UNITED STATES PATENT AND TRADEMARK OFFICE

10/829,606

DETAILED ACTION

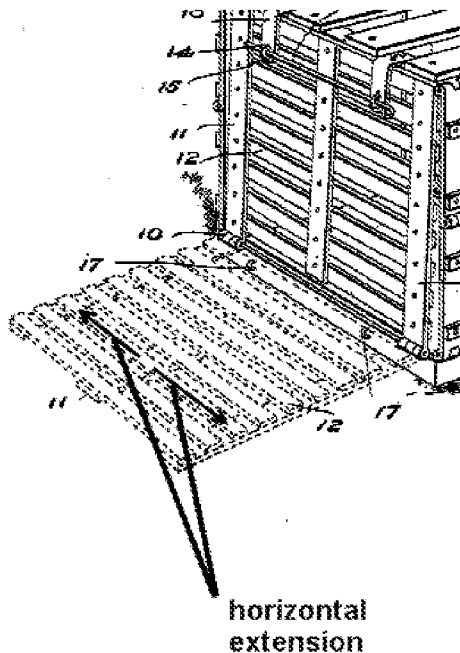
For claim 12, Schichtl teaches an enclosure for housing a pet litter pan in an interior portion thereof, said enclosure comprising an openable panel 11 having an interior face (upper face of ref. 11 where members 12 are mounted thereon), and an exterior face (face opposite upper face) and being pivotal between a closed position and an open position (see fig. 1), and further comprising at least two rails 12 extending

above and along the interior face of the openable panel, each of said rails being aligned in a direction (horizontal direction, see illustration below) extending outwardly from the interior portion when the openable panel is in its open position for sliding said litter pan thereon during insertion and removal of the litter pan to and from the interior portion.

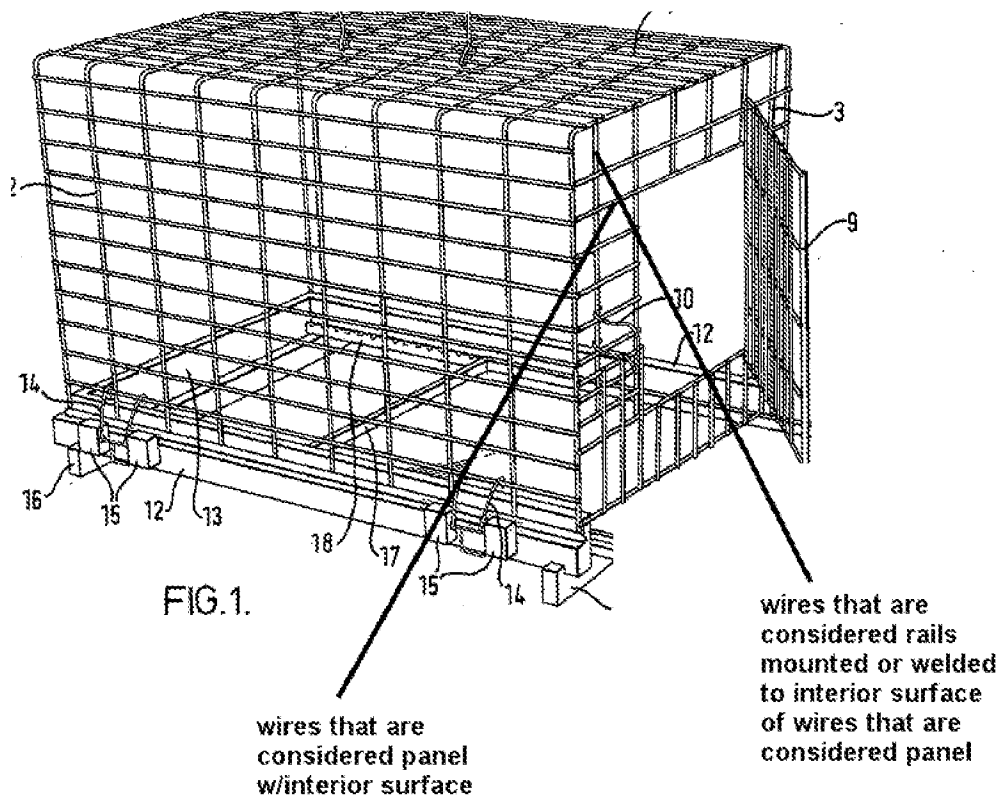
Applicant argued that the screen elements of the open mesh walls 4 disclosed by the Ho reference form the walls themselves, and are not raised above the interior face of the panel. Moreover, Ho's open mesh walls 4 are not hingedly or pivotally openable (rather, Ho's door 41 is openable within the fixed front wall.

Ho is now only employed for claim 24, which does not claim pivoting panels or rails. However, in response to the rails comment, the screen of Ho are made out of wires criss-crossing each other or one wire on top of another wire, to which the bottom wires are considered the panel and the top wire are considered the rails mounted on an interior surface of the bottom wires or panel. For example of the wire concept, see fig. 1 of Watling, which is reproduce below to provide the Examiner's interpretation of rails. This illustrates the same wire mesh as in Ho.
